Reference | Project Echidna Data Centre Eastern Creek (SSD-47320208)

## **Project Echidna Data Centre Eastern Creek** Meeting minutes and Concept DA consistency

Figure 1 | proposed development layout (including median strip planting)

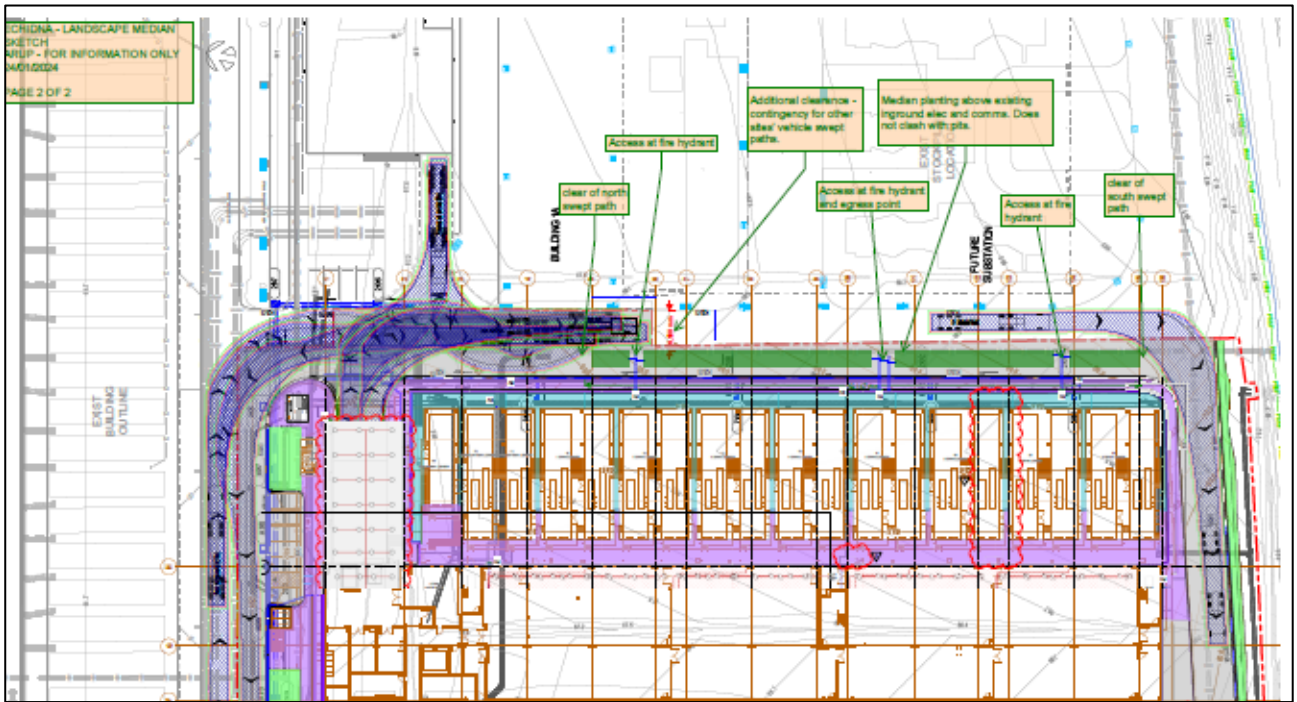
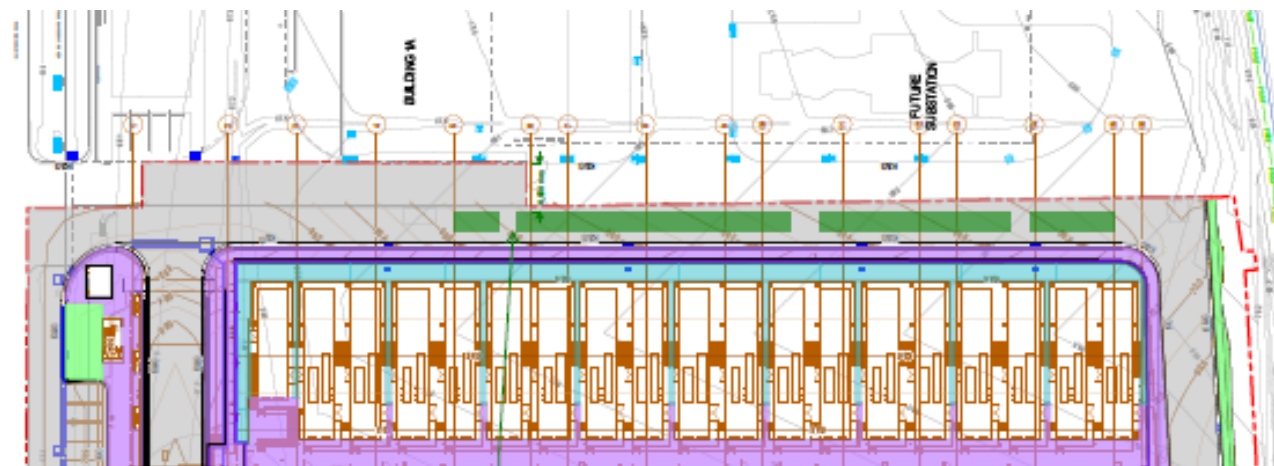
Following our meeting, we can confirm that we can include median strip planting along the internal road consistent with the approved Concept (ref SPP-19-00013). Figure 1 below shows the final proposed arrangement for this planting.

Consistent with the development consents, and specifically as shown below on Figure 2, the access and egress swept paths presented in the application for Building 1/1A partly limit the ability to provide median strip planting at the northern end of the road. We too are proposing to adopt the same arrangement. However, unlike the approved Concept, we are proposing to slightly widen the median strip for the remainder of the length of the road as shown on Figure 1 below.

## Figure 2 | extant consented planning layout accounting for the provided swept path analysis

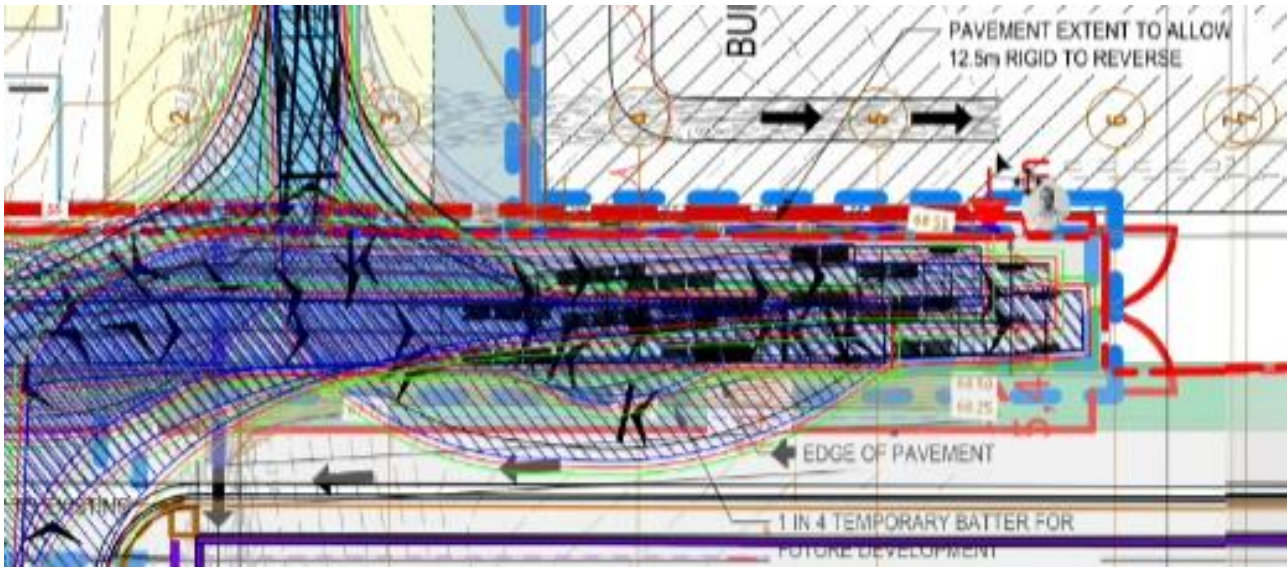
Our inclusion of the median strip planting maintains consistency with the three overlapping developments, the Concept (ref SPP-19-00013), Building 1/1A (ref MOD-21-00447) and the Substation (ref DA-22-01312), which were given consent in that order. We note that traffic and swept path analysis was prepared to support the latter two applications, which for reference we have overlain on the Concept DA below on Figure 2.
